適航指令發布單
Airworthiness Directive Issuance Form

民航局 AD 編號 AD number	CAA-2019-07-004	發布日期 Date issued	2019/7/10												
適用之航空產品 Applied to (models, serial numbers or part numbers, as applicable)	This AD applies to Rockwell Collins, Inc. (Rockwell Collins) Flight Display System Application FDSA-6500 part numbers 810-0234-1H0001, 810-0234-1H0002, 810-0234-1H0003, 810-0234-2H0001, 810-0234-2C0001, 810-0234-2C0002, and 810-0234-4B0001. These appliances are installed on, but not limited to, Bombardier Inc. Model CL-600-2B16 (604 variant) airplanes and Textron Aviation Inc. Models 525B, B200, B200C, B200CGT, B200GT, B300, B300C, and C90GTi airplanes, certificated in any category.														
主旨摘要	Operating limitations on TCAS by revising the limitations section of the AFM or AFM supplement and installing a placard on each aircraft PFD														
民航局 CAA <input type="checkbox"/> 本國產品 Native products <input type="checkbox"/> 其他個案 Other	設計國民航主管機構 Original Authorities

Airworthiness Directives; Rockwell Collins, Inc. Flight Display System Application

2019-12-09 Rockwell Collins, Inc.: Amendment 39-19664 ; Docket No. FAA-2019-0469 Product Identifier 2019-CE-028-AD.

Figure 1 to paragraph (g)(3) of this AD; placard location on bezel

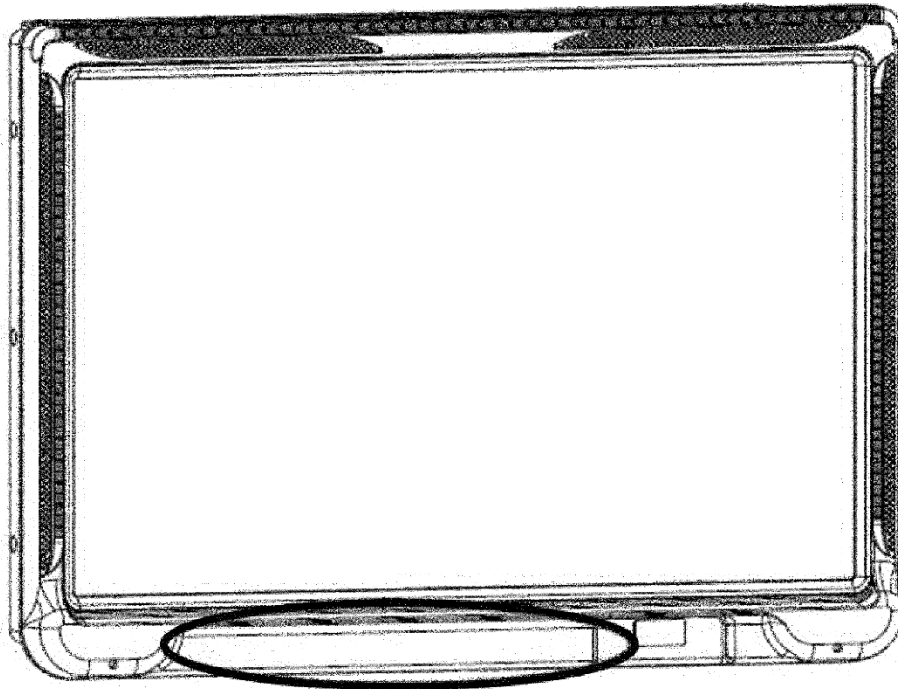
(2) Fabricate a placard for each aircraft primary flight display, using at least 1/8 inch letters, with the following text: TCAS Flight Ops–TA Only mode (TA/RA mode prohibited).

(3) Install the placard on the bottom of each aircraft primary flight display bezel in the area depicted in figure 1 to paragraph (g)(3) of this AD.
